KEADBY 3 CARBON CAPTURE POWER STATION

Document Ref: 9.14

Applicant's Response to Action Points arising from Hearings

Date: April 2022

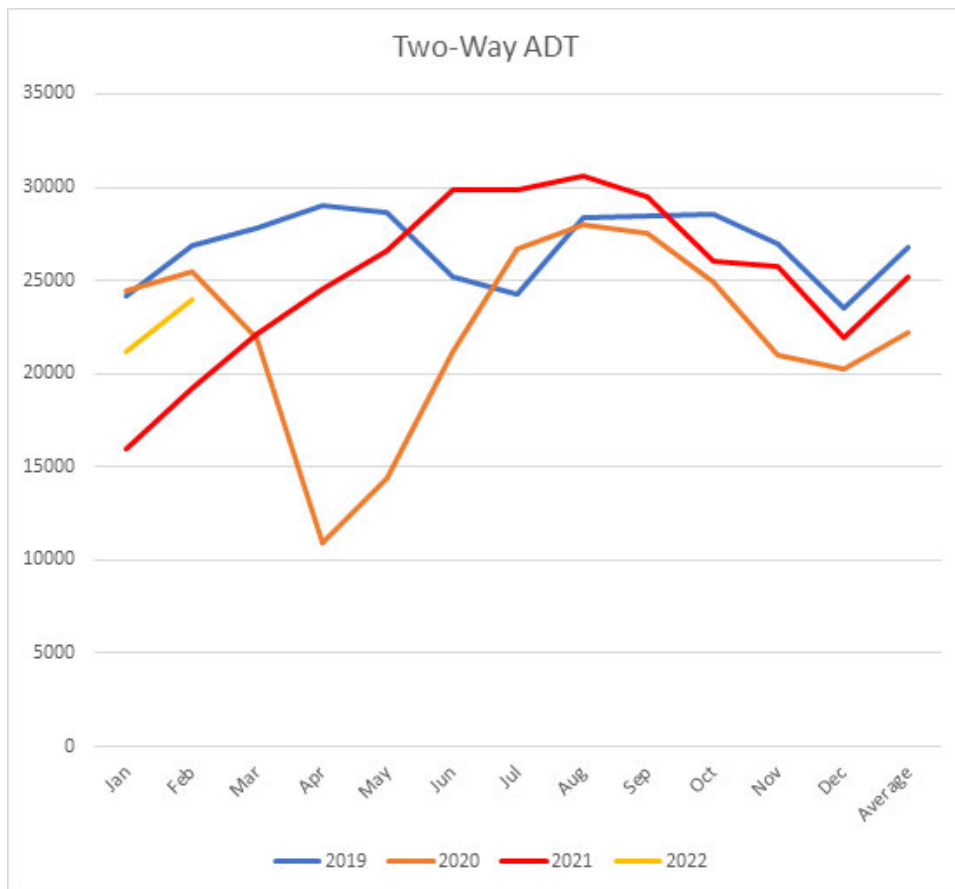
2.9.1 *“Submit a written response as to whether the Applicant can provide an assessment of traffic levels pre/ post-pandemic.”*

2.9.2 Traffic count analysis of locations using monthly two-way AADT count data from 2019, 2020 and 2021 on the M180 J3 close to the Keadby site. We've then created an average figure over the year. This data has been extracted from the National Highways Webtris portal.

2.9.3 The data shows that in 2020 flows dropped significantly compared with 2019, but in 2021 were climbing again towards 2019 levels, but had not quite reached the same level. Therefore, essentially flows are returning to normal, but aren't yet at pre-pandemic levels.
